Review of Clause 36 (PCS) : Link Monitor & Synchronization

IEEE 802.3z interim meeting January 27th 1997

Bit Synchronization State Diagram (Fig. 36-18)

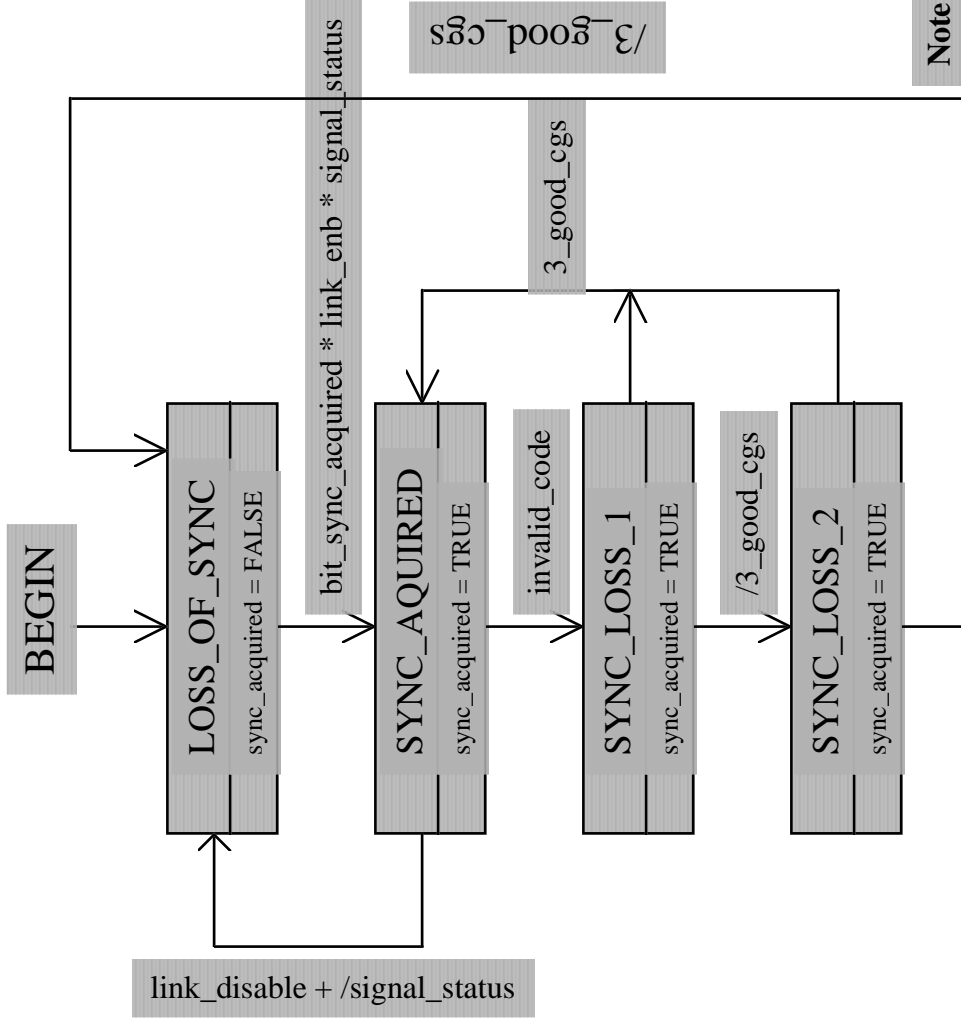
Note: PMA_UNITDATA.indicate is assumed for all transitions

Code Synchronization State Diagram (Fig. 36-19)

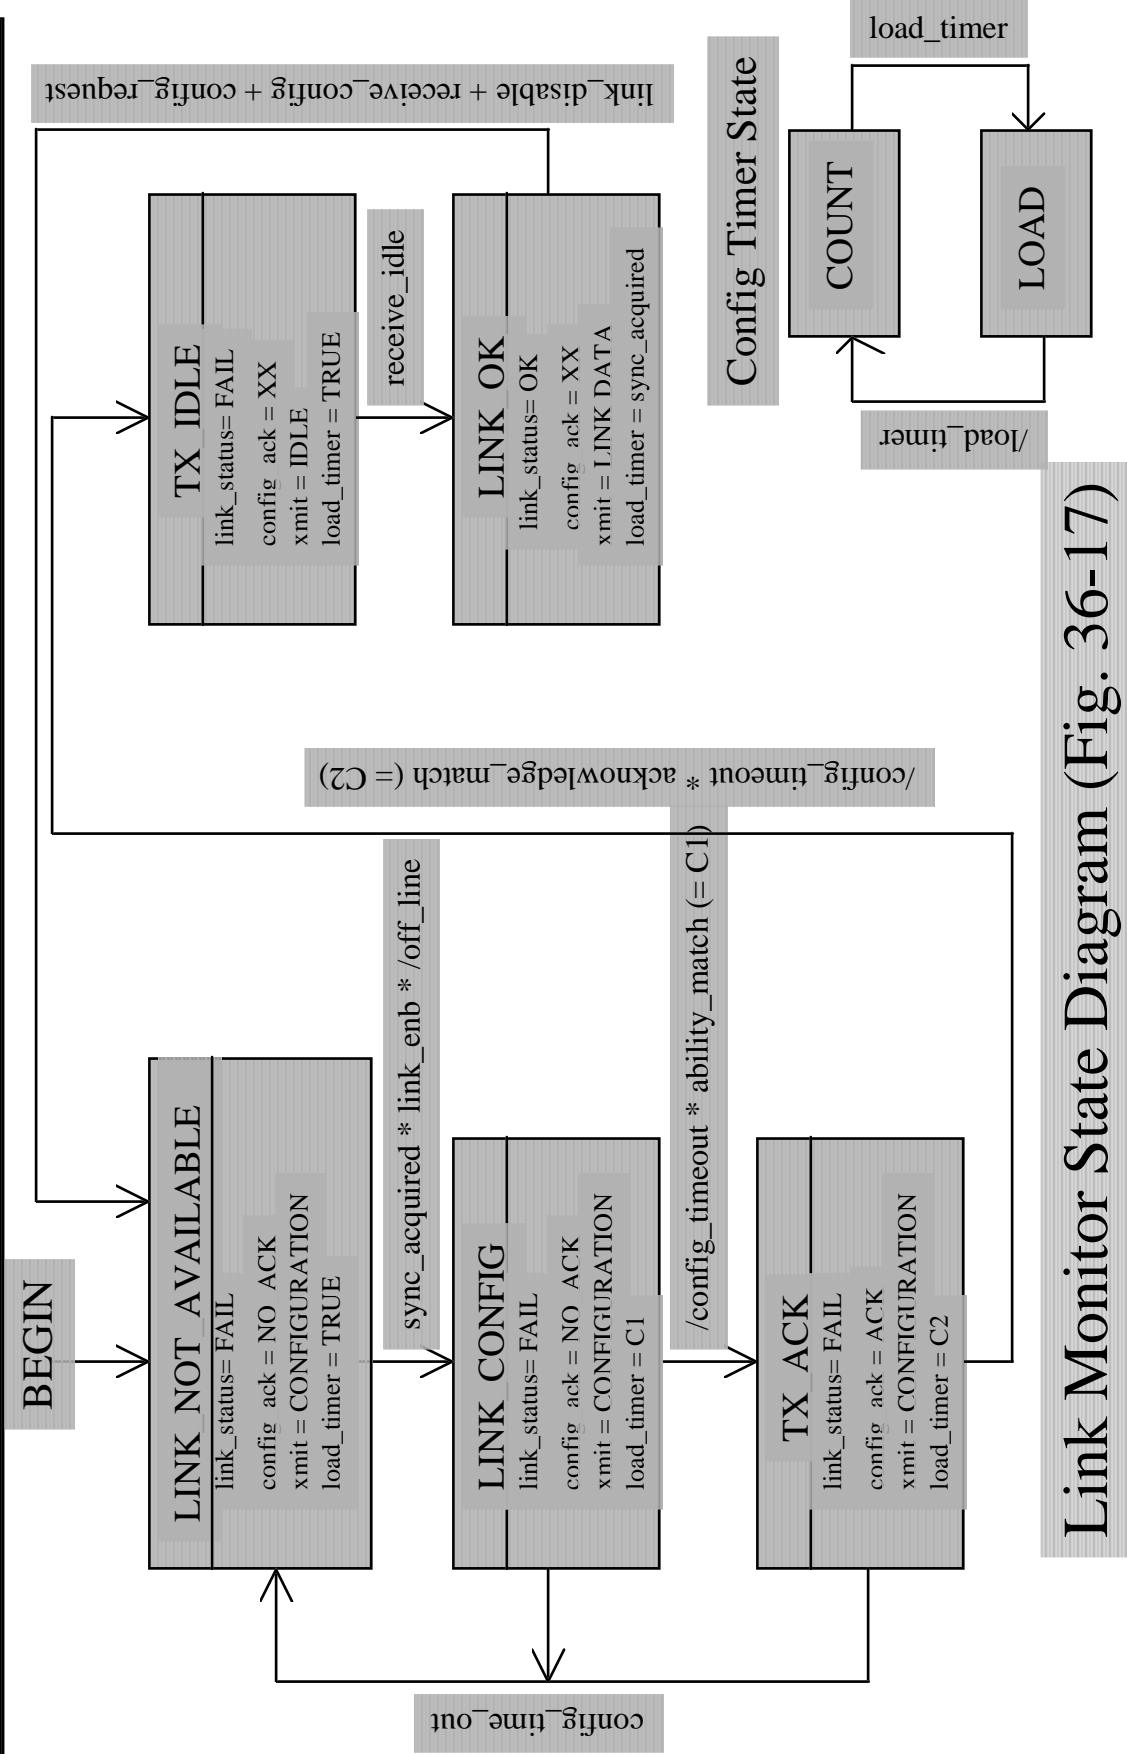
Note: PMA_UNITDATA.indicate is assumed for all transitions
